May 7, 1979

PRELIMINARY APPRAISAL OF THE THREE MILE ISLAND ACCIDENT

Preliminary Appraisal of the Three Mile Island Accident

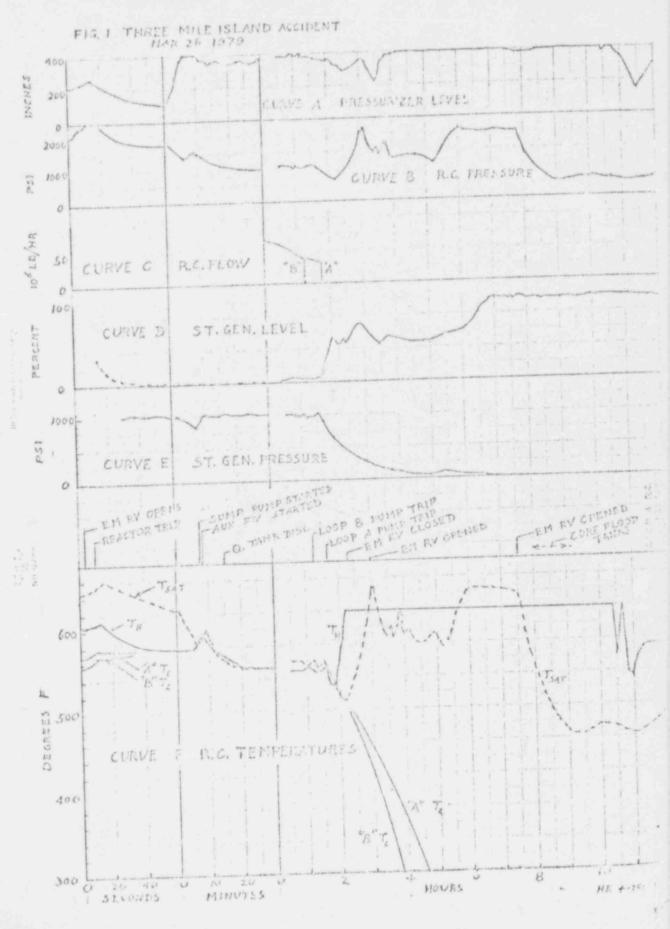
Introduction. The Committee has reviewed some of the data recorded during the Three Mile Island accident - the most important data are shown in attached Fig. 1. It seems clear that material balances and heat balances, in conjunction with recorded data not yet available to the Committee, will lead to an accurate history of the condition in the reactor, at least up to the time the reactor coolant pumps were tripped.

It is evident, as discussed later and as suggested by Curve F of Fig. 1. that, after the initial blowdown, the hot leg (at least) was at saturation temperature throughout the first 100 minutes. The void fraction is determined by the volumetric loss of primary system invent: y. With no HPI or makeup pump, the loss of water and steam through the EMRV (electromatic relief valve) may be about 1 percent per minute of the system volume. This would also be the vate of void formation. The heat balance will reflect temperature changes necessary to generate the required steam. Thermal expansion and contraction is reflected in a change of void fraction of about 0.15 percent per OF (depending on amount of subcooling).

On this basis, Curve A of Fig. 1 indicates the presence of voids throughout most of the accident, increasing from 40 to 100 min. The decreasing coolant flow shown in Curve C confirms this by the evident progressively increasing pump cavitation.

1. The transients during the first 15 sec., following loss of main feedwater supply, follow a normal course, i.e., pressure rise, actuation of the EMRV, opening and closing of the safety valves, and other transients shown in Fig. 1. Failure of the EMRV to close is the governing factor in subsequent events. The effect of the delay in auxiliary feedwater flow was transient.

2. With the EMRV open, the system blows down to saturation pressure in a few minutes. Curve F of Fig. 1 shows that this occurs in 6 min., and calculation from the pressurizer steam inventory gives 7 min. During the first minute, the pressurizer level falls about 100 in. from the peak (Curve A). About 70 in. of this is accounted for by thermal contraction and about 30 in. by loss of pressurizer water by flashing during the blowdown.

The rise of 220 in. in the pressurizer level between 1 min. and 4 min. occurs before the temperature has dropped to saturation (Curve E). General voiding of the system is therefore precluded as the cause of the rise. No completely satisfactory explanation for this rise is offered. There has been a rise in the average system temperature (average of T_{H} and T_c , not adequately shown in Fig. F) of 2 to $3^{\circ}F$. This could account for 45 in. rise in pressurizer level. The strain relaxation of the steel boundary under a 400 psi pressure drop would account for only 1-1/2 in. Each of the three high pressure injection pumps woulr raise the level at the rate of 20 in./min. or 80 in. during the four minute period. The pumps could therefore easily account for the rise, but information on the pump history is confusing and the curve from which Curve A is drawn does not show discontinuities such as would be expected in starting and stopping pumps. Recent information suggests that one pump was running at capacity and one in a controlled mode. Voiding in the core is possible, but, with full flow circulation of subcooled water to remove decay heat,

It would be possible to operate in different modes at different times, but Fig. 1 shows that with the possible exception of the period 11-18 min. the system remained at saturation pressure throughout (Curves A and F). The following comments are therefore addressed to the saturated condition.

4. With the system at saturation, the fluid in the hot leg is two-phase, i.e., saturated water and steam. The steam voids increase progressively, with time, and cavitation of the reactor coolant pumps increased correspondingly (Curves A and C). It is concluded that misinterpretation of the level indication led to continued loss of inventory from the system.

6. The system at no time appeared to suffer from serious loss of cooling capacity, except possibly during the period between 5 and 8 minutes. Curve F shows, with the steam generators dry, a rapid rise of temperature, and Curve B shows a corresponding rise of pressure. If the auxiliary feedwater supply had not been started, the pressure rise would presumably have continued until the safety valves opened.

2. When the EMRV was isolated half an hour later, the pressure (Curve B) and saturation temperature (CurveF) rose gradually to a condition in which natural circulation might possibly have been induced.

- (a) The wide spread between T_C and T_H. In forced circulation with all four pumps, this should be about 1°F at 100 min. If the natural recirculation rate were 5 percent of this, the spread would be only 20°F as compared with the wide spread indicated in Curve F.
- (b) Availability of steam-table saturation temperature/pressure data proposed by Mr. Mathis. This would have shown, not only that natural circulation should not have been attempted, but also that T_H started to indicate superheat immediately, showing atsence of water at the hot-leg temperature sensor.
- (c) Immediate loss of steam generator pressure (Curve E).
